**TOWN OF LOS GATOS**  
**PLANNING COMMISSION STAFF REPORT**  
**Meeting Date: October 10, 2012**

**APPLICATION NO:** Architecture and Site Application S-12-074

**LOCATION:** **109 Spreckles Avenue** (westerly side of Spreckles Avenue, just north of Loma Alta Avenue)

**APPLICATION SUMMARY:** Requesting approval to demolish an existing single-family residence and to construct a new residence on property zoned R-1:20. APN 532-30-047.

**EXHIBIT B:**

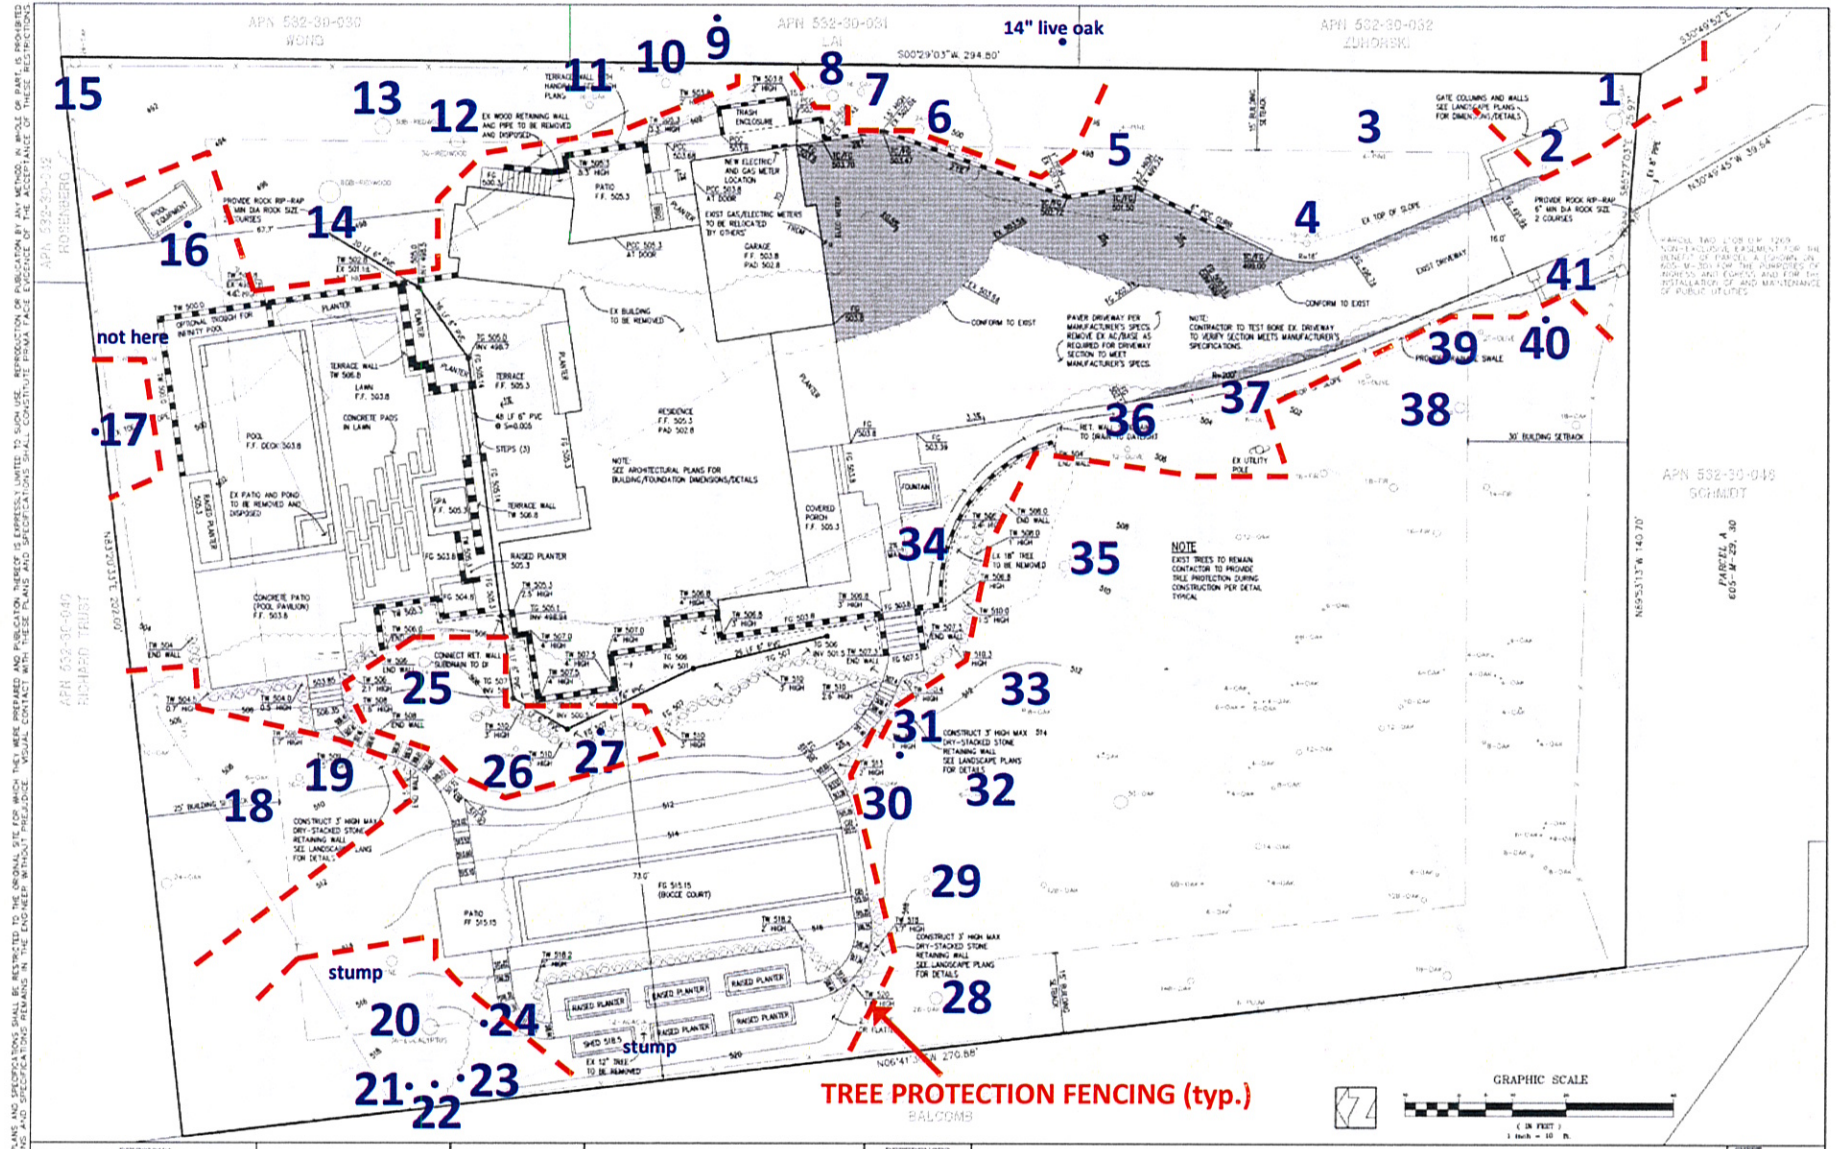
The following **nine trees** are not shown on the project plans, and I have added their roughly approximate trunk locations (in blue circles) to the map presented in Exhibit B: **#9, 16, 17, 21-24, 31 and 40.**

- **Tree #24:** The full impact is unknown as the tree is not shown on the project plans. My estimated trunk location identifies it may conflict with the proposed path. If retained and protected, I recommend a minimum protection zone of five feet from the trunk for any soil disturbance.
